January 31, 2014

Re: Stormwater Permit Response  
Bulk Sampling Activity

This letter serves to transmit to your office responses to comments dated December 20, 2013.

GENERAL ARRANGEMENT  
 GRAVEL PILE TRUCK ESCAPE RAMP  
 ACCESS ROAD 3  
 NOT TO SCALE

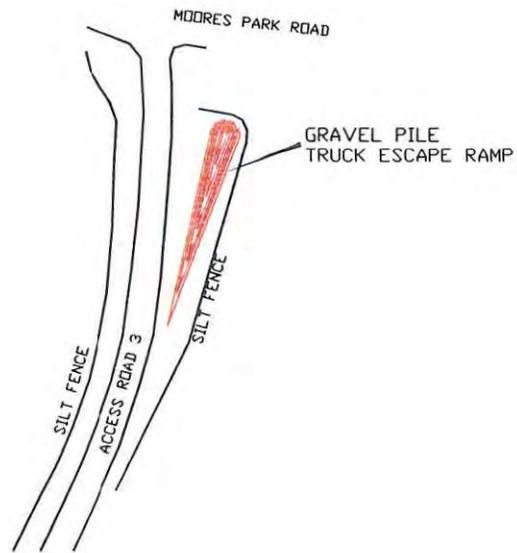
1. Please provide a detail of the Runaway Truck Protection Area.

**RESPONSE:** The Runaway Truck Protection Area is provided as a workplace safety feature.

The construction will consist of a pile of small sized stone placed along Access Road 3. The pile is configured so that it forms a vee shape. The shortest part of the vee faces the uphill side of Access Road 3. The pile becomes progressively larger in the downhill direction. The intent of the pile is to provide a form of energy dissipation to stop a vehicle if there is a problem with stopping.

A sketch accompanies this text to provide a concept. The dimensions and configuration of the pile may vary to fit field conditions.

<b>BULK SAMPLING PROJECT</b>		BARR PROJECT No. <b>49261006.03</b>
ACCESS ROAD 6 PLAN & PROFILE		CLIENT PROJECT No. 
DWG. No. <b>C003</b>	REV. No. <b>D</b>

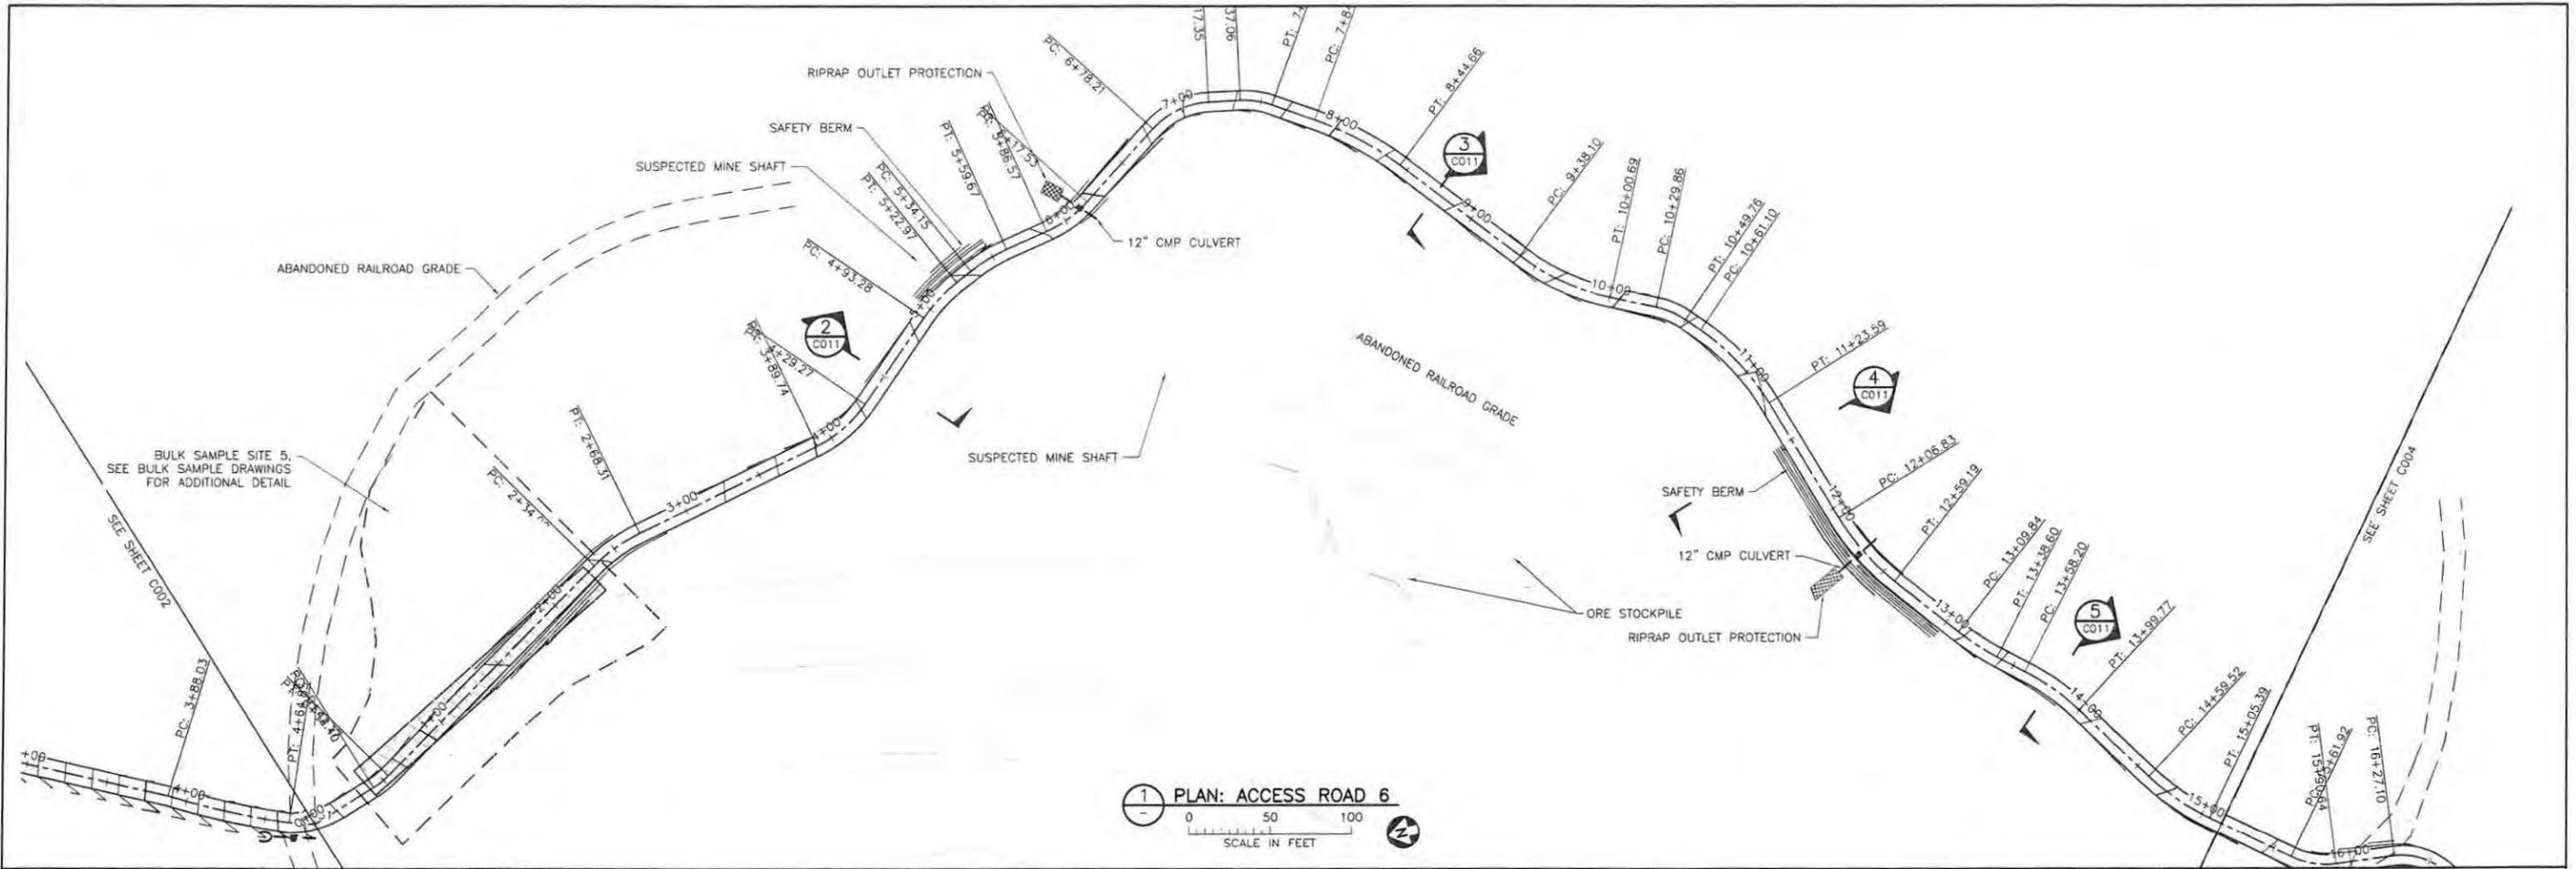
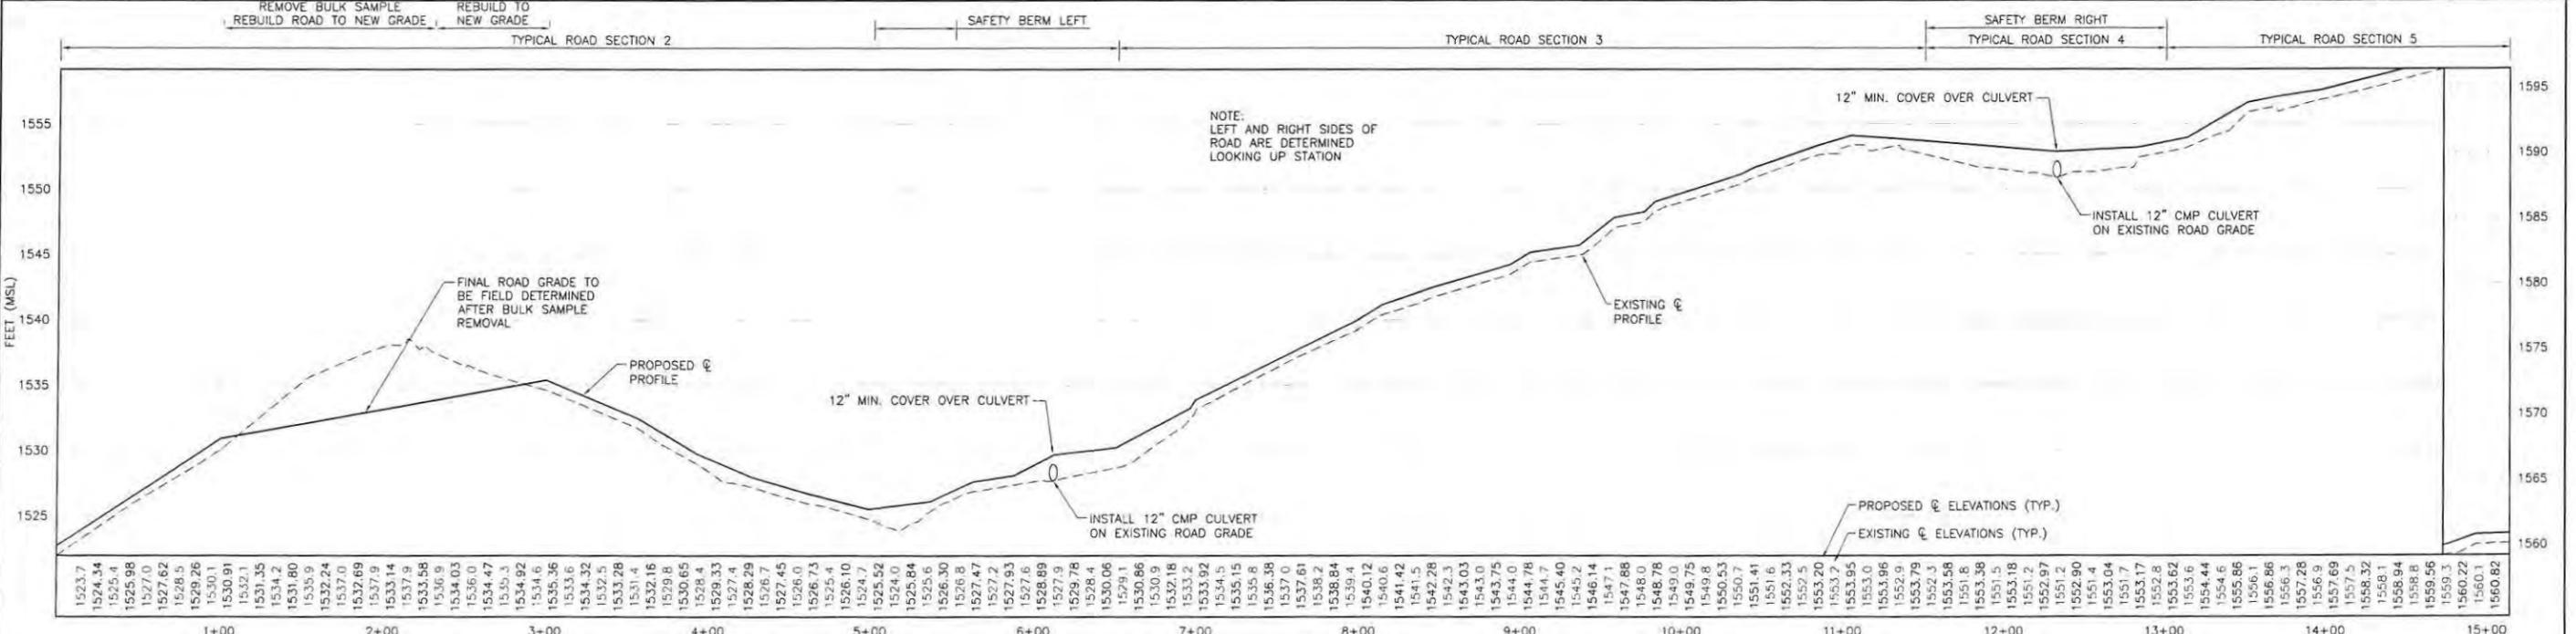
b. Station 12+50 is the low spot that will receive water from around 400 feet of roadway and an undefined drainage basin. Stormwater is proposed to discharge over the road in this area and right into the proposed safety berm. Based on conversations with your design engineers, a cut in the berm to pass this water was inadvertently omitted. Please provide a revised plan sheet that details this area and shows the opening in the berm. Also your analysis should serve to help you evaluate whether a culvert is warranted here.

**RESPONSE:** A culvert is proposed at Station 12+30 to follow the natural drainage patterns. All drainage is proposed to pass through the culvert and not cross over the road.

The reporting drainage area above the proposed culvert at 12+30 is 1.95 acres. Peak Surface Runoff has been calculated at 1.87 cubic feet per second based on a 10 year 24 hour storm event. The Peak Surface Runoff for a 2 year 24 hour storm event would be 0.85 cubic feet per second.

BULK SAMPLING PROJECT	
ACCESS ROAD 6 EROSION AND SEDIMENT CONTROL PLAN	
BARR PROJECT No. 49261006.03	CLIENT PROJECT No.
DWG. No. C007	REV. No. D

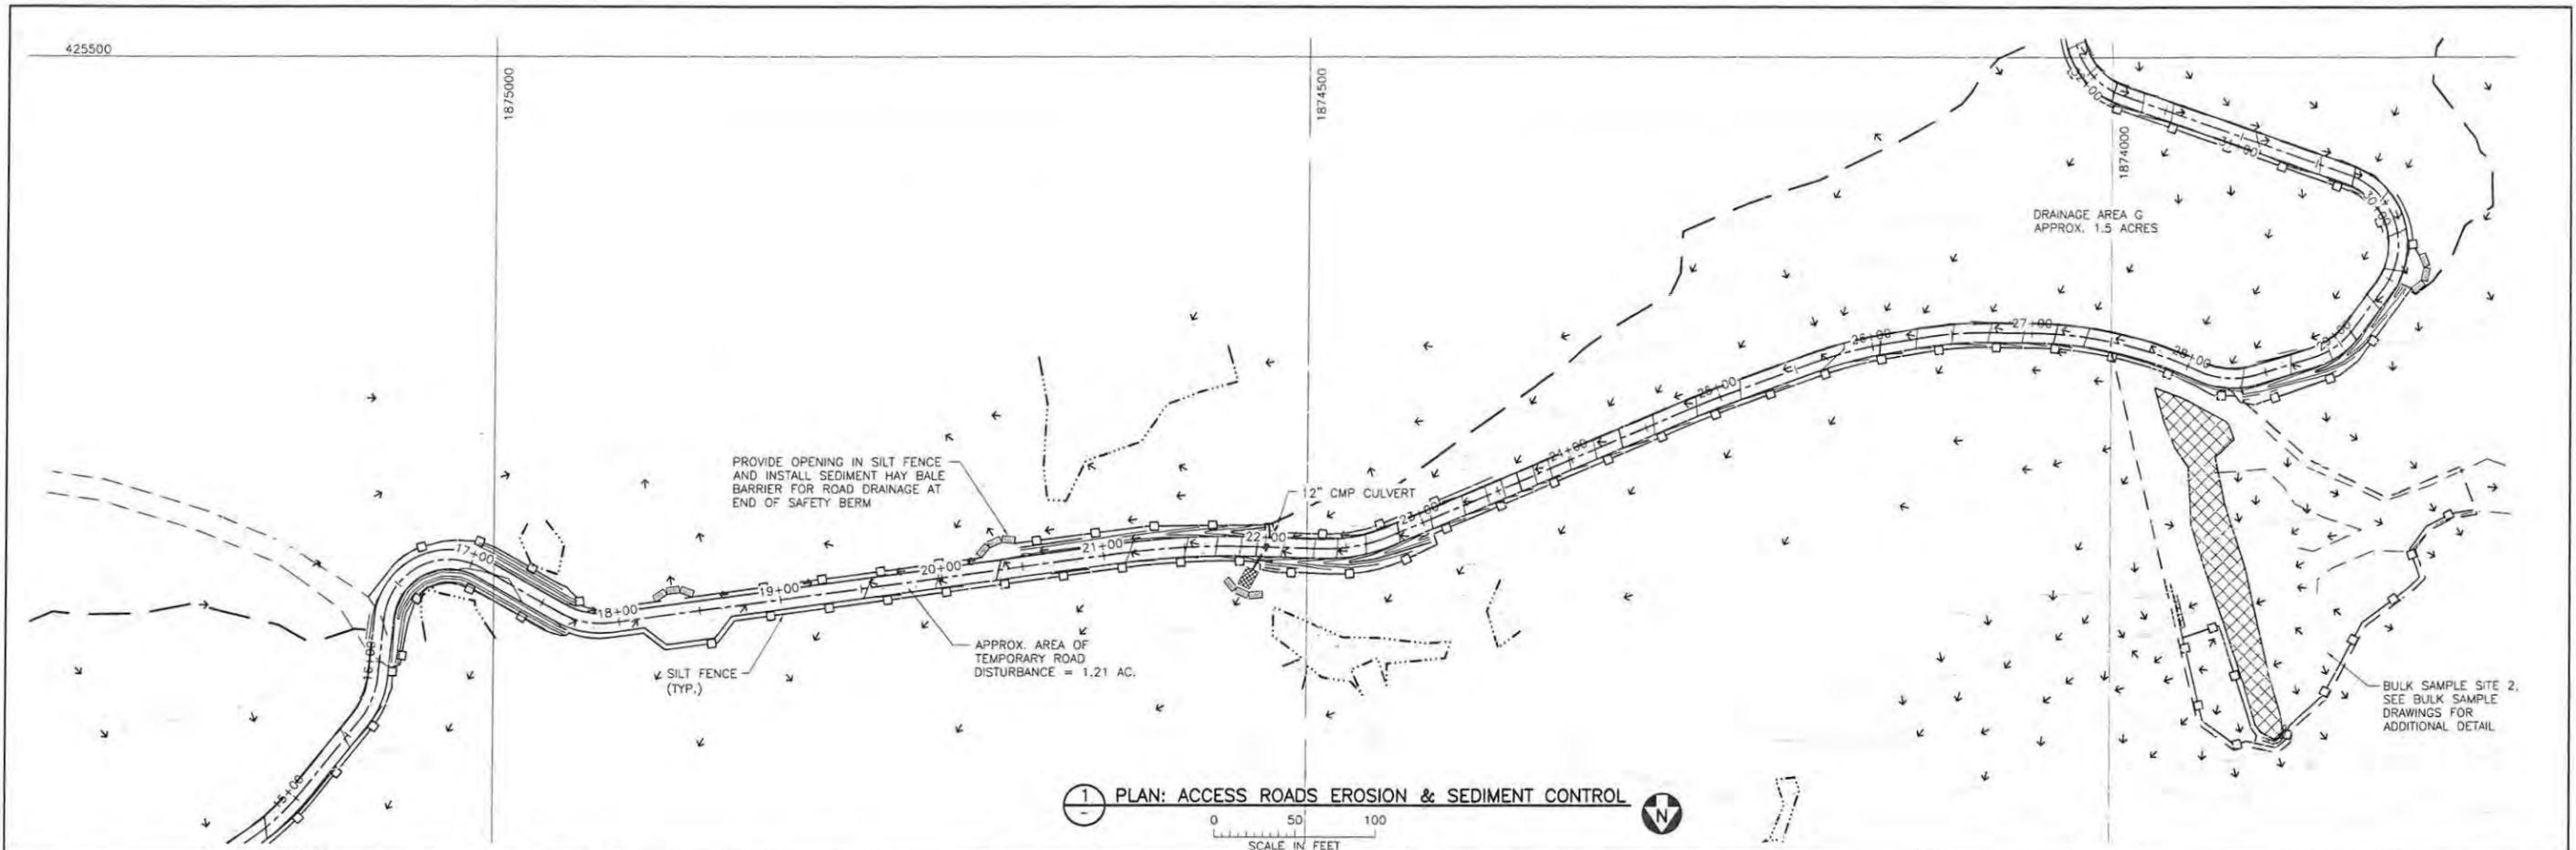
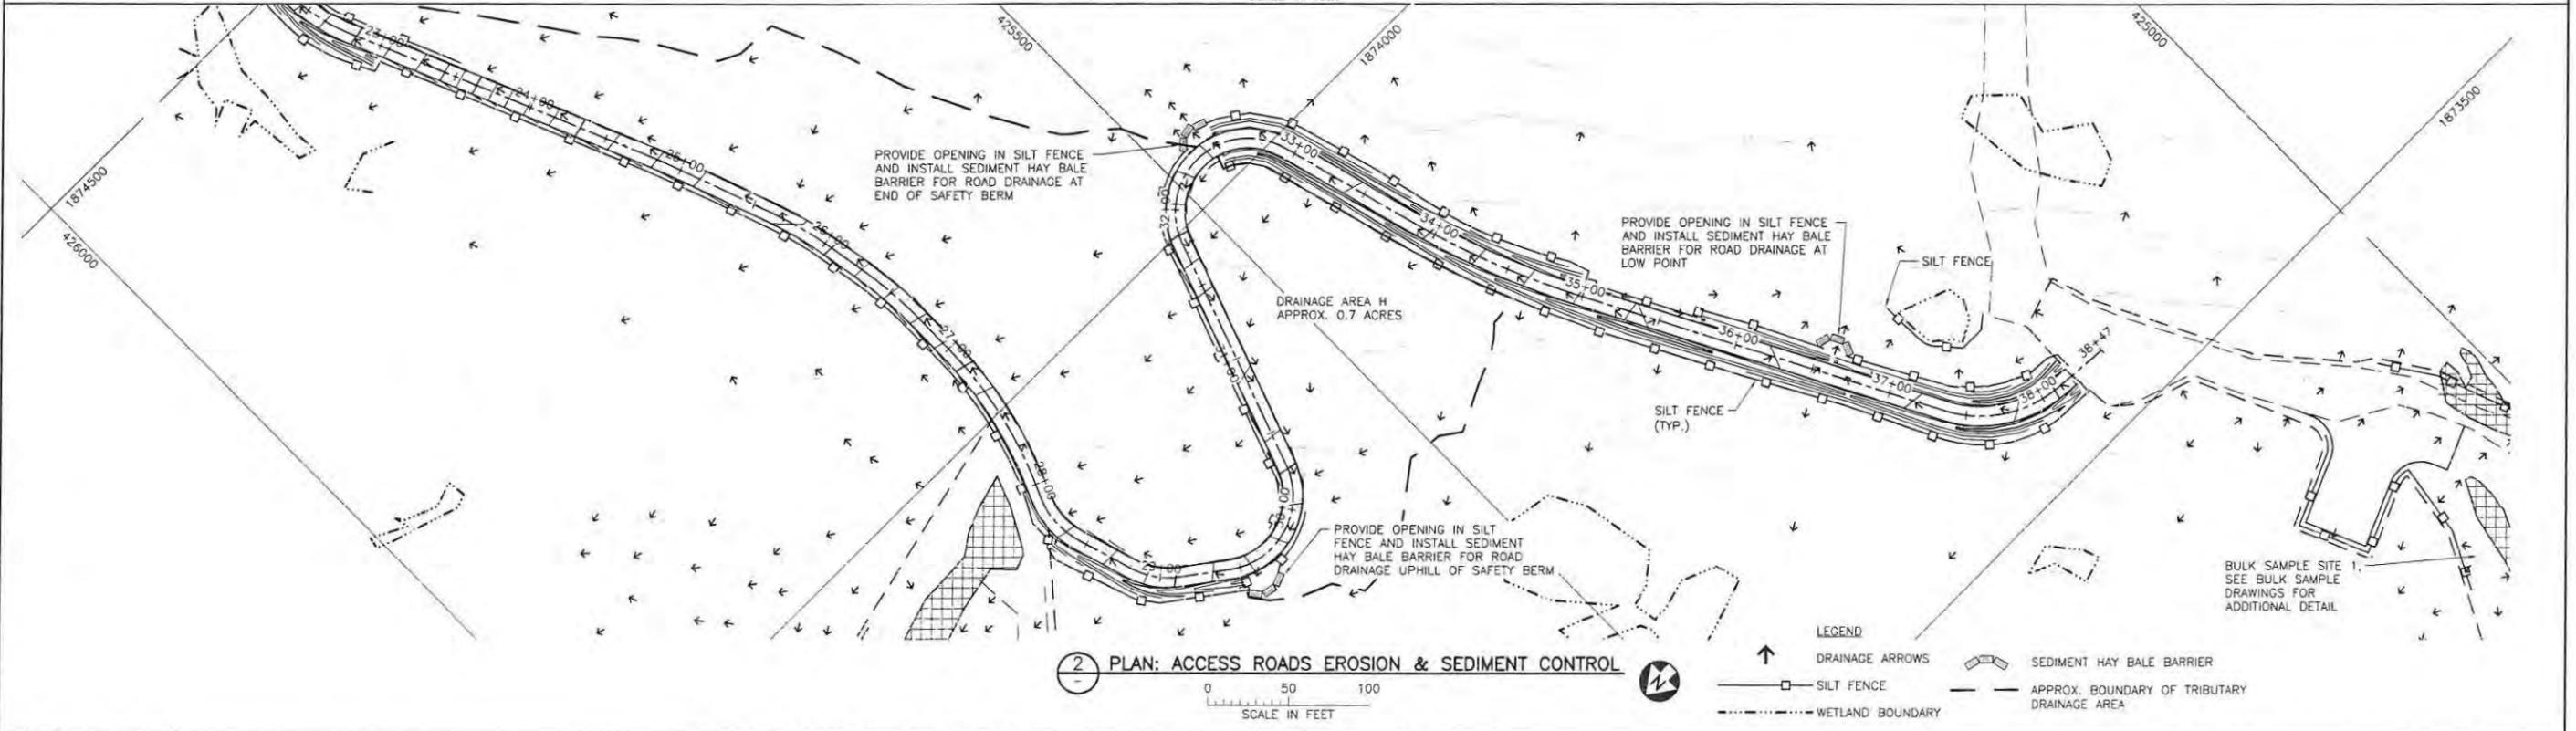
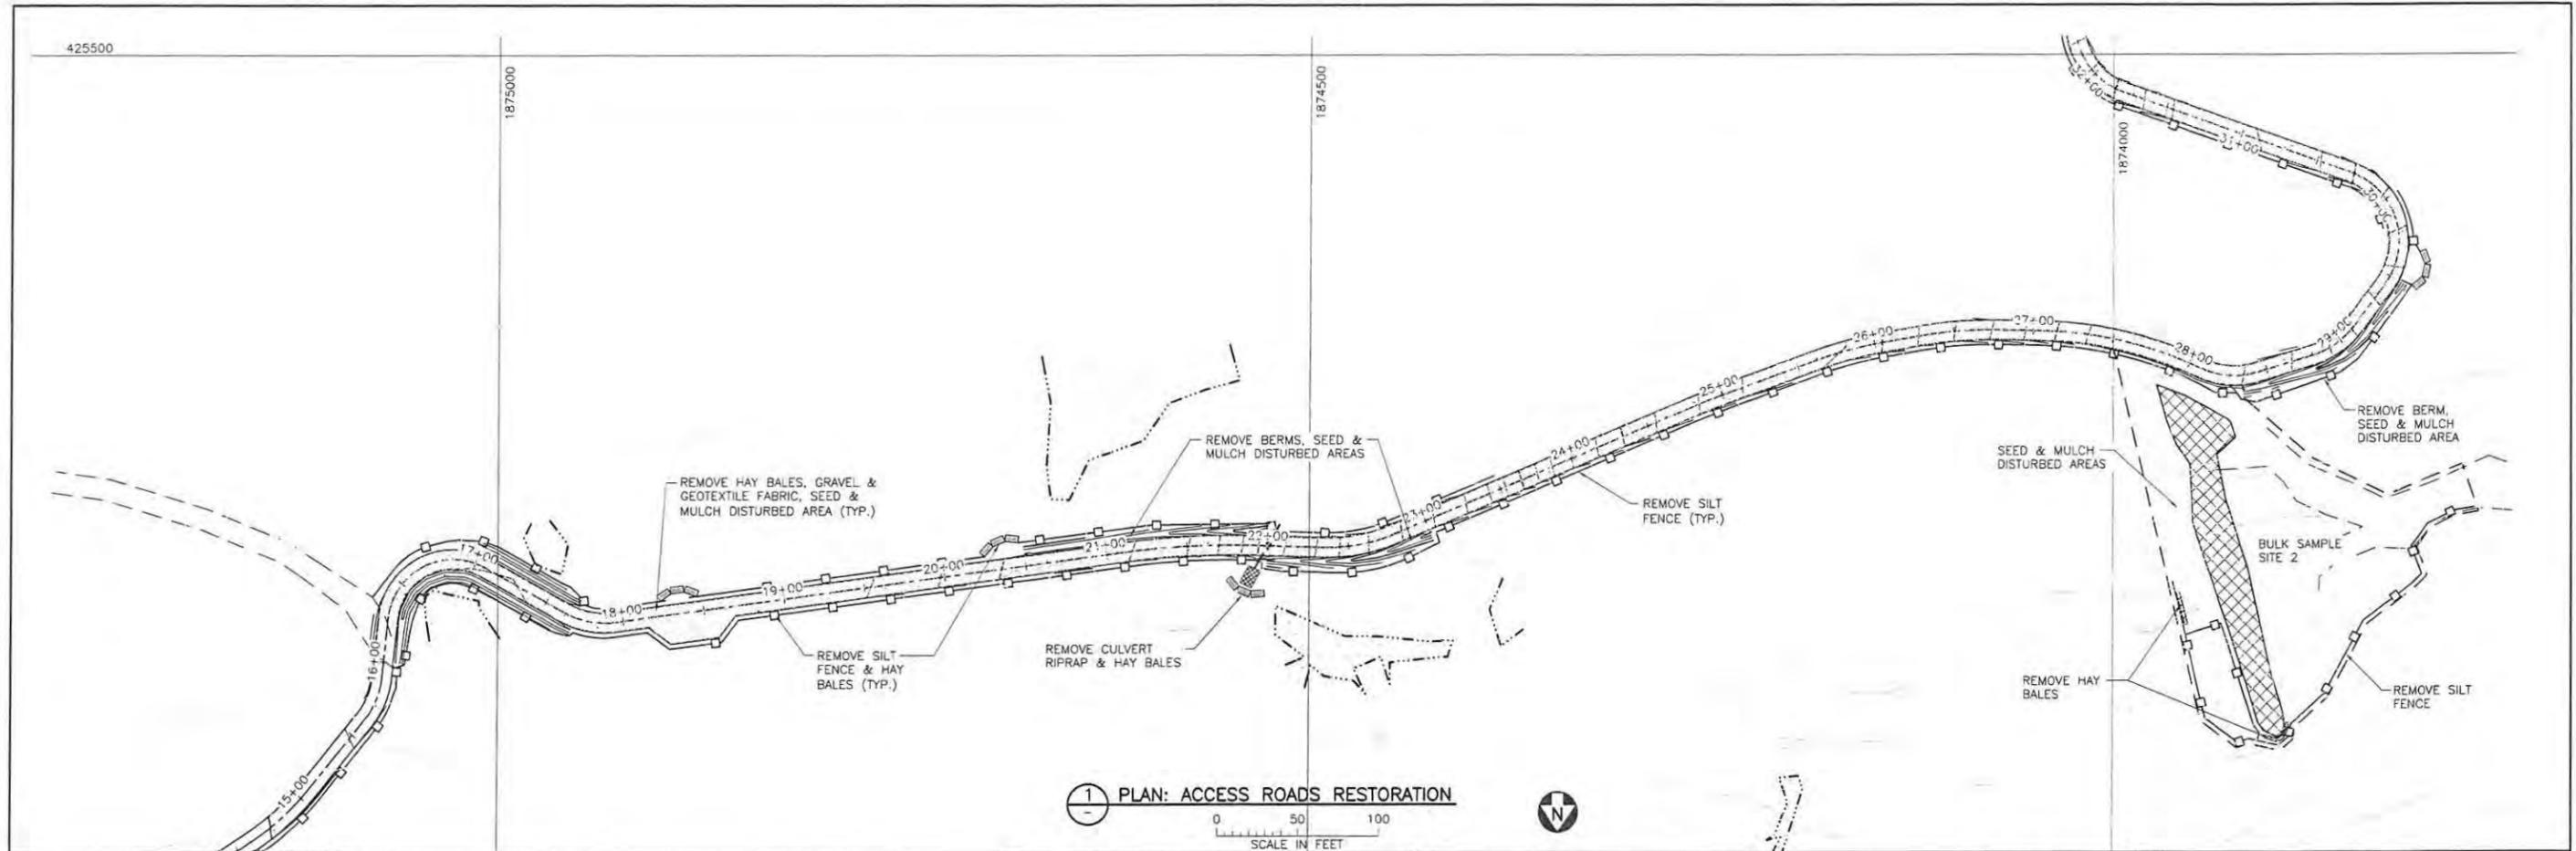
21. On the plan it is unclear where water will discharge at Station 36+80. Based on conversations with your engineer, it is your intention to take the water south. If so, you will need to protect the downslope wetland (Wetland 7) with a BMP like silt fence. Please fix this in the plan and provide a detail.

**RESPONSE:** Refer to Sheet C007. Silt fence is proposed around the north perimeter of the wetland. Runoff is allowed to exit the road through a hay bale sump.
